FRIENDSHIP SUBDIVISION

APPLICATION NUMBER 15 DATE August 18, 2005
APPLICANT Friendship Subdivision
REQUEST Subdivision

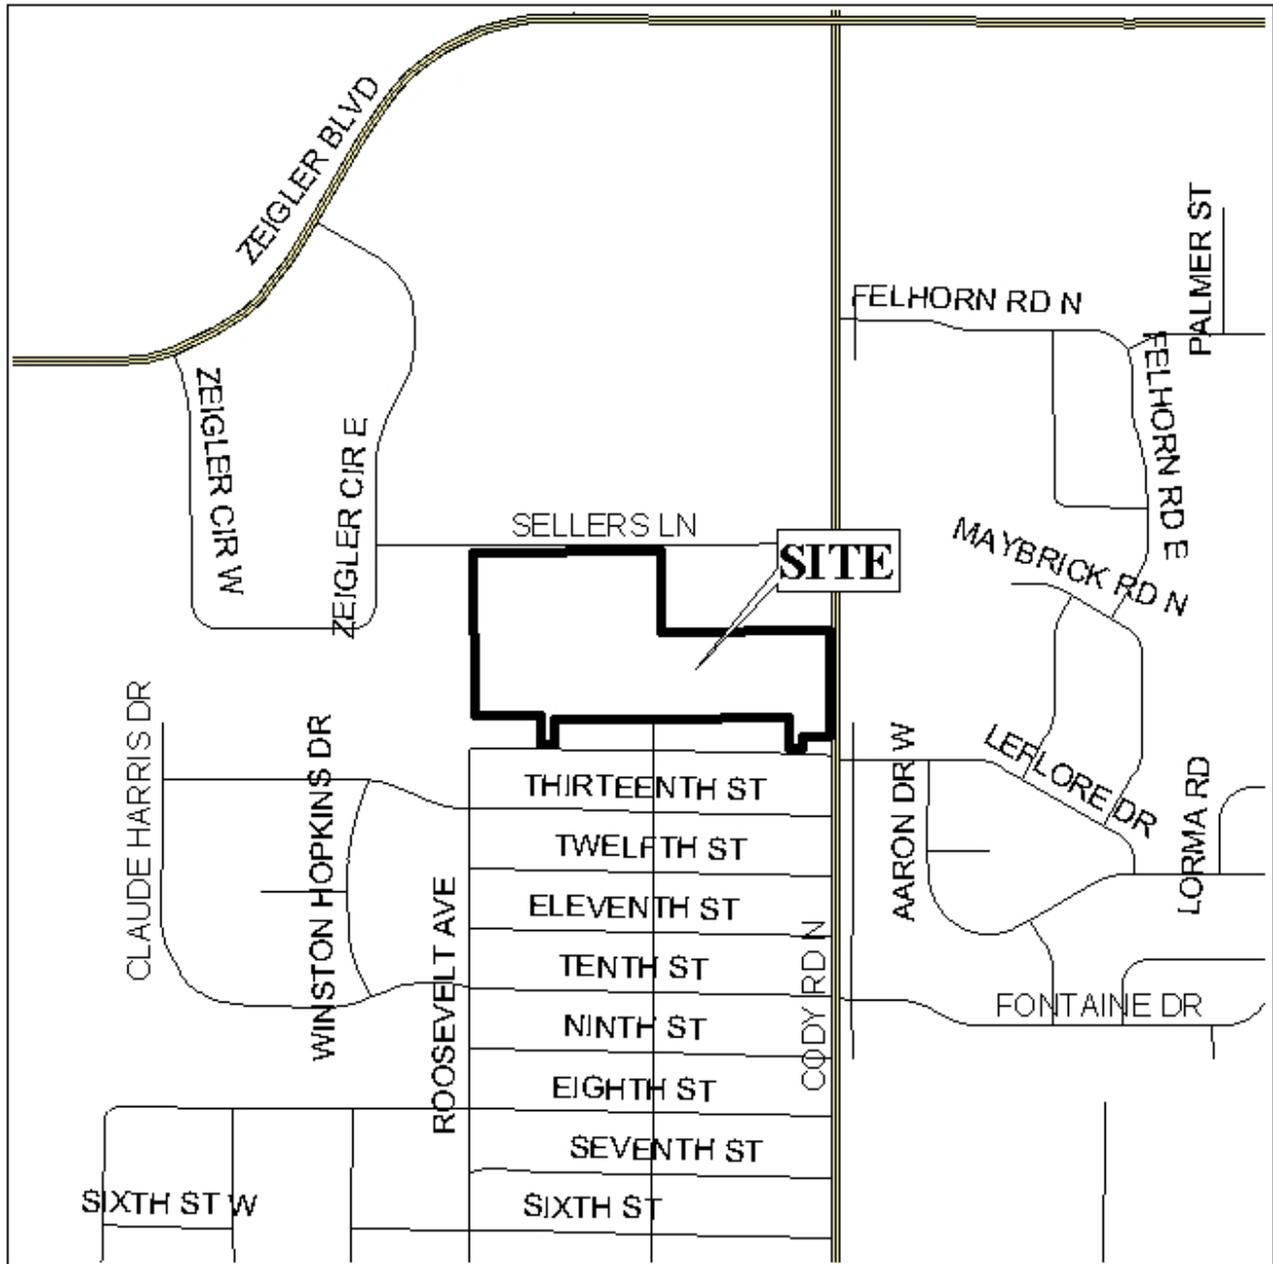
Engineering Comments: Must comply with the Mobile County Flood Damage Prevention Ordinance.

The site fronts Cody Road, a planned major street, which has an existing right-of-way shown of 50-feet; the Major Street Plan requires a 100-foot right-of-way. Therefore, the dedication of adequate right-of-way to provide 50-feet from the centerline of Cody Road should be required. Additionally, as a means of access management, the placement of a note on the final plat stating that the site is limited to the two existing curb cuts to Cody Road should be required. Furthermore, the site should be denied access to Fourteenth Street, Lincoln Boulevard and Sellers Lane, which are in residential neighborhoods.

This site is located in the County, thus a note should be placed on the final plat stating that any lots which are developed commercially and adjoin residentially developed property must provide a buffer, in compliance with Section V.A.7. of the Subdivision Regulations.

The plat meets the minimum requirements of the Subdivision Regulations and is recommended for Tentative Approval subject to the following conditions: 1) the dedication of sufficient right-of-way to provide 50-feet from the centerline of Cody Road; 2) the placement of a note on the final plat stating that the site is limited to the two existing curb cuts to Cody Road; and 3) the placement of a note on the final plat stating that direct access to Fourteenth Street, Lincoln Boulevard and Sellers Lane are denied.
